MEMORANDUM

To: Dabyne Planning Pty Ltd
Address: PO Box 179, Jindabyne NSW 2627
From: Nick Wilson / James Alexander
Project: 13 Crackenback Drive, Thredbo NSW
Subject: BCA Compliance Statement

Date: 6 July 2022
Project No.: 2232
Revision: A

Figure 3 – window location western elevation

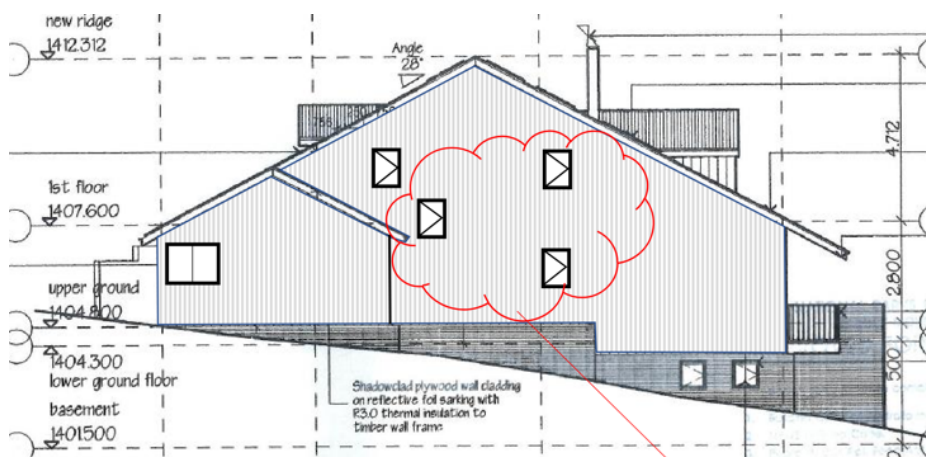
The proposed Development Application seeks consent to undertake alterations and additions comprising of the replacement of 3 existing windows on the western elevation with three identically sized windows, matching in colour and frame material and provided with double glazing in lieu of the current single glazing. The location of the subject window replacement can be seen below.

Figure 4 – western façade location to the boundary

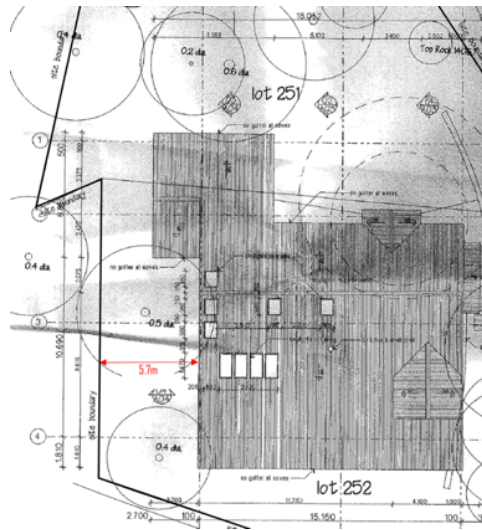
Clause 3.7.2.4 (c) requires openings in external walls of class 1 building, that are required to be fire resisting under 3.7.2.2, to be protected by non-operable fire windows or other construction achieving an FRL of -/60/-. Clause 3.7.2.2 requires an external wall of a class 1 building, and any openings in that wall, to be protected if the wall is less than 900mm from the allotment boundary. The subject wall, where the proposed windows are to be replaced, is in excess of 900mm (5.7m) from the boundary and therefore no protection is required. This can be seen in the figures below.

Figure 5 – First floor window location

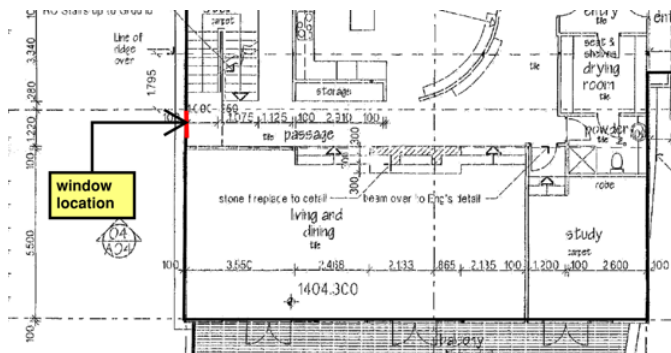
As the existing fixed windows, and the replacement windows are identical in shape size and location, no variations to the existing light and ventilation has occurred. Form the desktop assessment of the supplied plans the existing openings provide natural light to the stairs and passageway which is not considered as habitable space under the BCA and therefore exempt to these clauses.
